From: Dombrowski, Frank J <frank.dombrowski@wecenergygroup.com>
Sent: Thursday, March 30, 2023 9:38 AM
To: Werner, Leah
Cc: Krueger, Sarah E - DNR; 'staci.goetz@ramboll.com'; Abigail Small (ASMALL@ramboll.com); Luke, Glenn R; Julie A Zimdars (Julie.Zimdars@ramboll.com); Dave MacDougall; Dan Vachon (Dan.Vachon@ramboll.com); 'adrienne.korpela@jacobs.com'
Subject: WPS Green Bay MGP - Modified Confirmation Sampling plan for Zone 4 Excavation Area
Attachments: Zone 4 Sampling Plan_Flat.pdf

PROPOSED POST-EXCAVATION SAMPLING PLAN

REMOVAL ACTION WORK PLAN
FORMER GREEN BAY MANUFACTURED GAS PLANT
 WISCONSIN PUBLIC SERVICE CORPORATION
 GREEN BAY, WISCONSIN

FIGURE 6

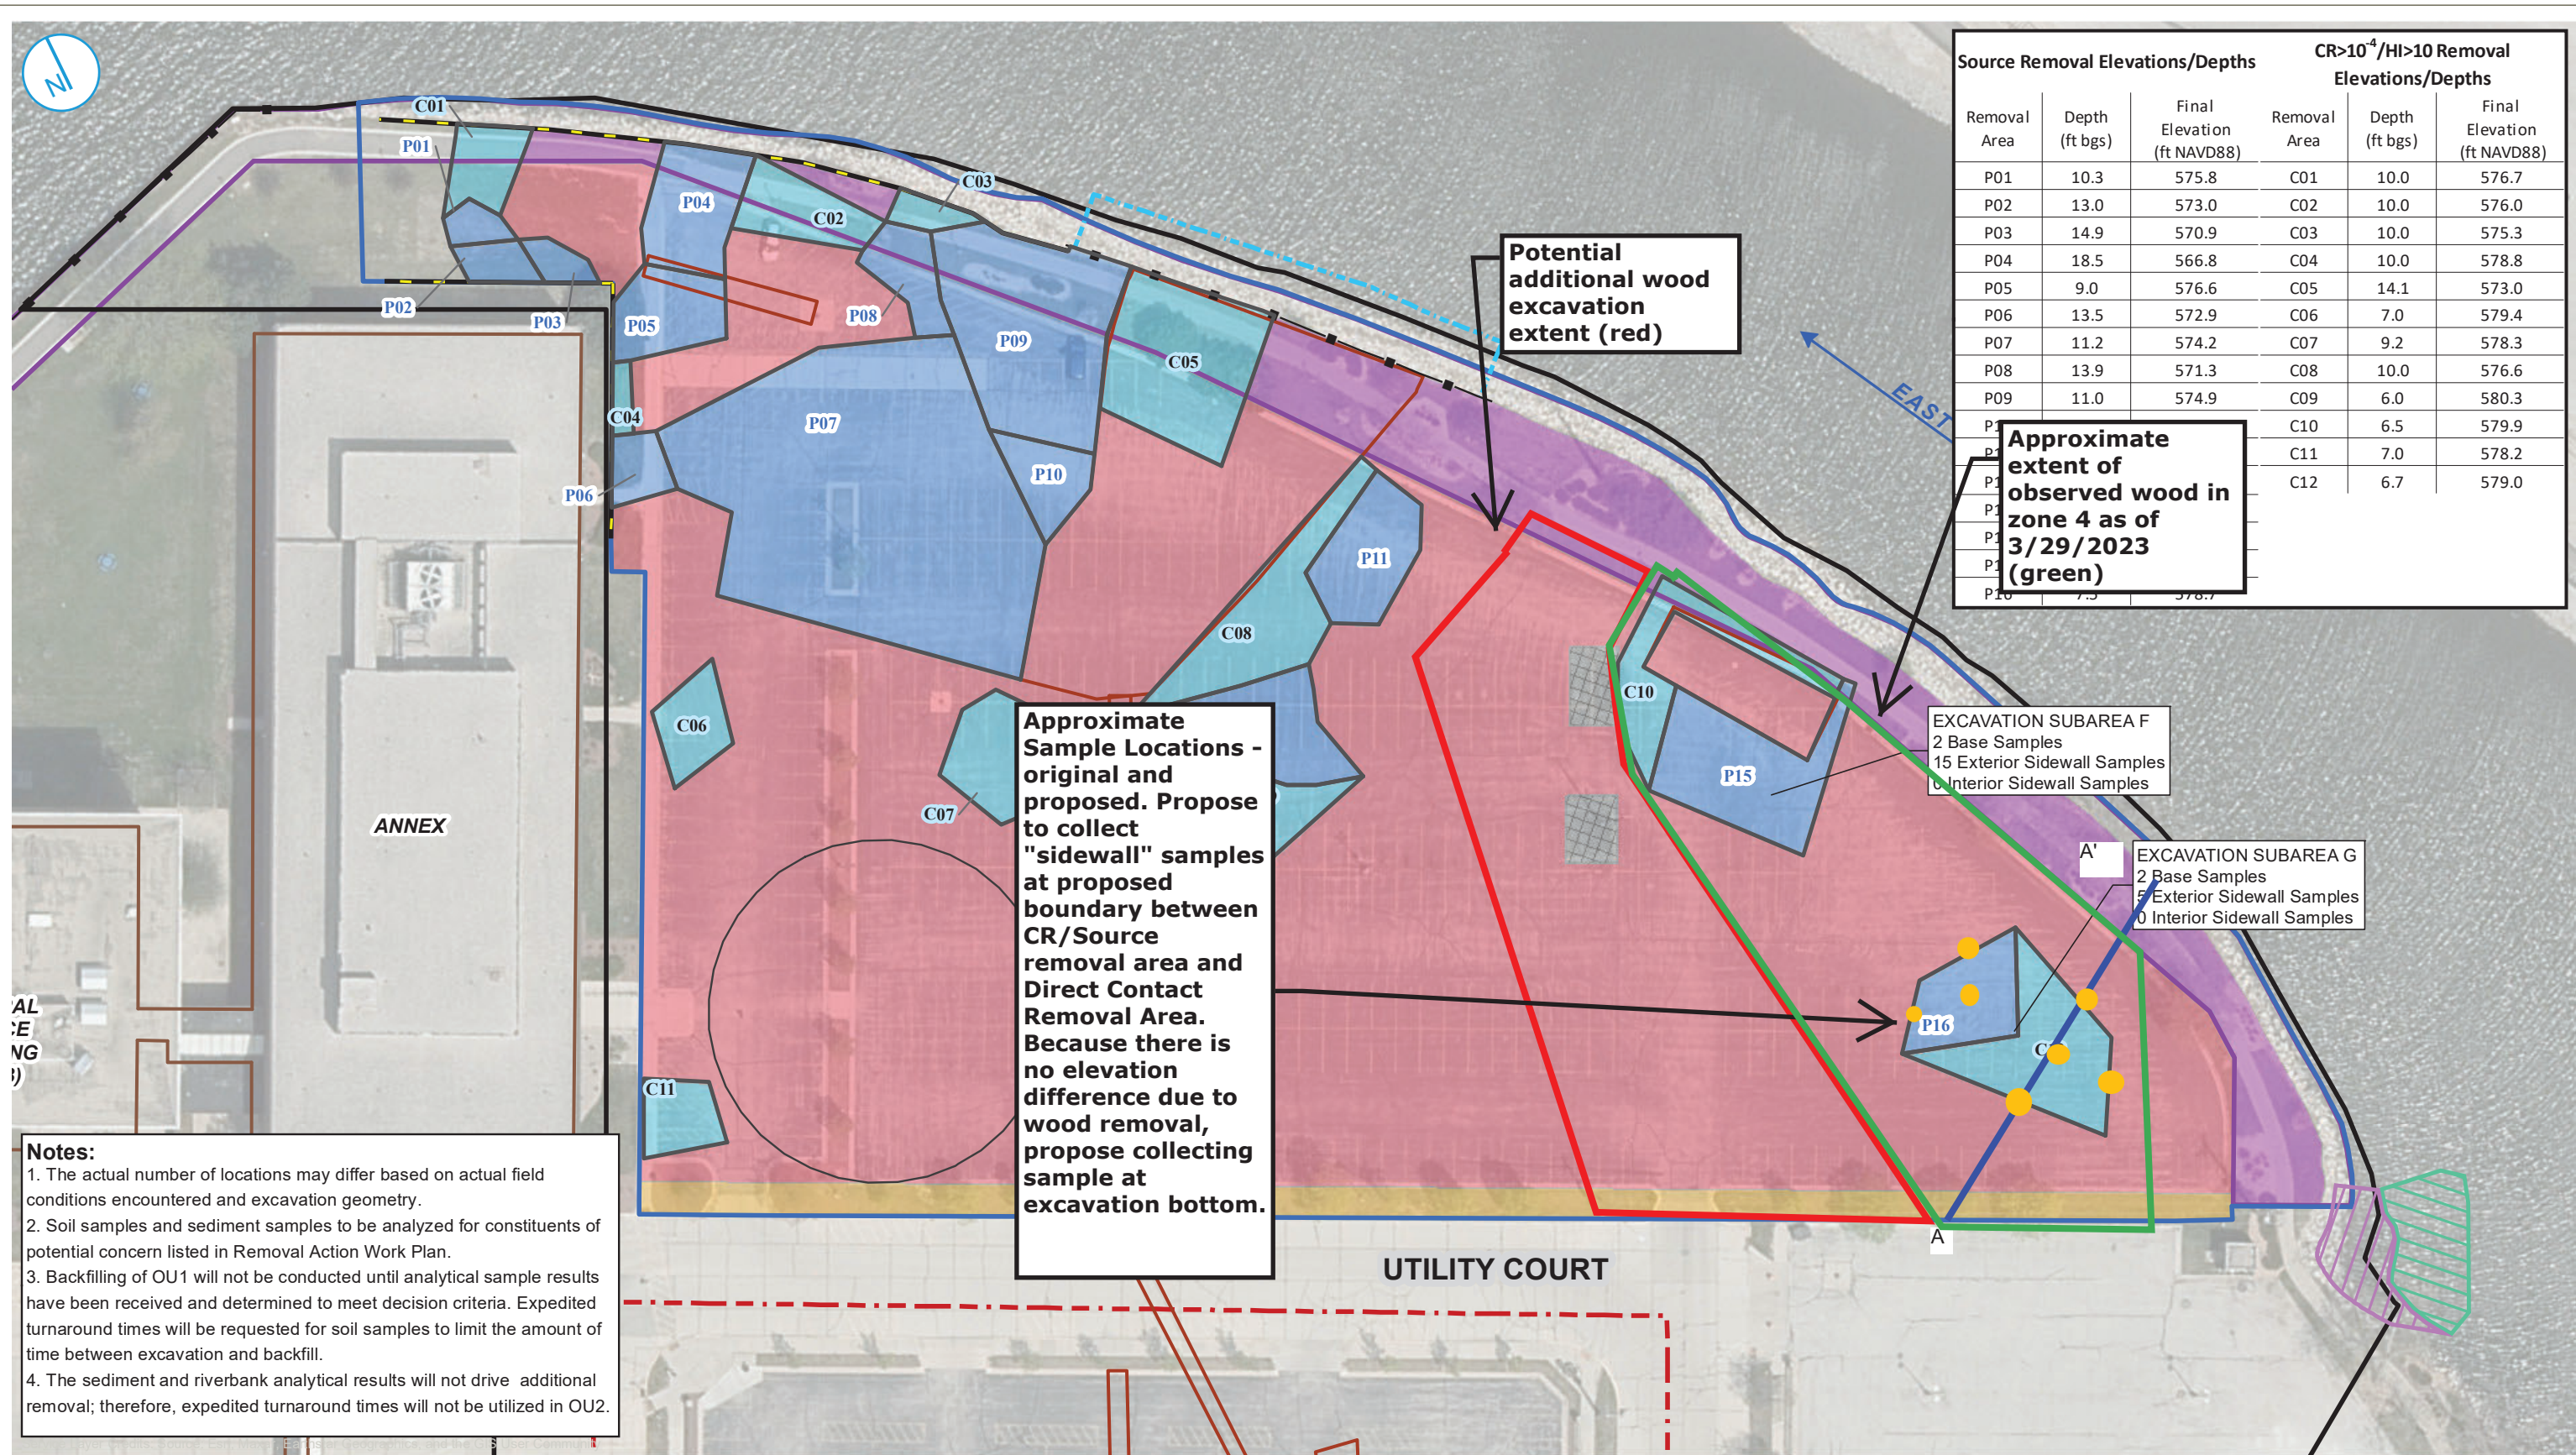
As we have begun excavating the Zone 4 area (east side of the site, green outlined area on the attached map), we are encountering a layer of wood/timbers at the bottom of the proposed excavation base elevation in the shallow cut areas. We are not sure if the wood is also present in the red shaded areas on the map but plan to remove it if it is. The proposed direct contact removal was to elevation 580 or 581 ft NAVD88 and the wood is present fairly consistently from approximately 578 to 580 ft NAVD. The wood doesn't appear significantly impacted or odorous (i.e., there is no evidence that it is source material/principal threat waste). However, the wood layer is considered geotechnically unsuitable soil for building footings (layer is around depth of 5 ft.) or good quality pavement construction. As a result, we have determined it is best to remove the woody material along with the associated overburden.

We are reaching out to explain our preferred path forward for post-excavation confirmation sampling following wood removal. Our current post-excavation sampling plan includes collection of bottom and sidewalls in source/CR zones and no sampling in the direct-contact/four-foot surface excavation areas. However, because of the removal of wood, the Zone 4 area surrounding cells P16 and C12 is being taken down to a consistent elevation of approximately 578 ft NAVD88. Because of the wood removal, there is no longer an elevation difference between the source removal areas (i.e., cells C12/P16) and the surrounding direct contact removal zone meaning that there will be no sidewalls remaining to sample. The attached figure also includes a rough cross-section showing the proposed and current grades around cell C12.

Where there are no sidewalls at the boundaries between source area/CR cells and direct contact areas, we intend to collect confirmation samples at the excavation bottom at the locations corresponding to the originally proposed sidewall samples (obviously any impacts that would have been identified in the sidewall samples from these locations will have been removed). Approximate locations around P16 and C12 are shown on the attached figure. Excavation in cells C10 and P15 has not yet begun but is expected to commence soon, as noted during last week's project status call. If there are sidewalls to sample, we would move forward with our original proposed plan and sample the sidewalls. If there are no sidewalls, we would intend to follow a similar approach and sample at the anticipated boundary between the two zones at the excavation bottom elevation. Please let us know if you have any questions or would like to discuss further.
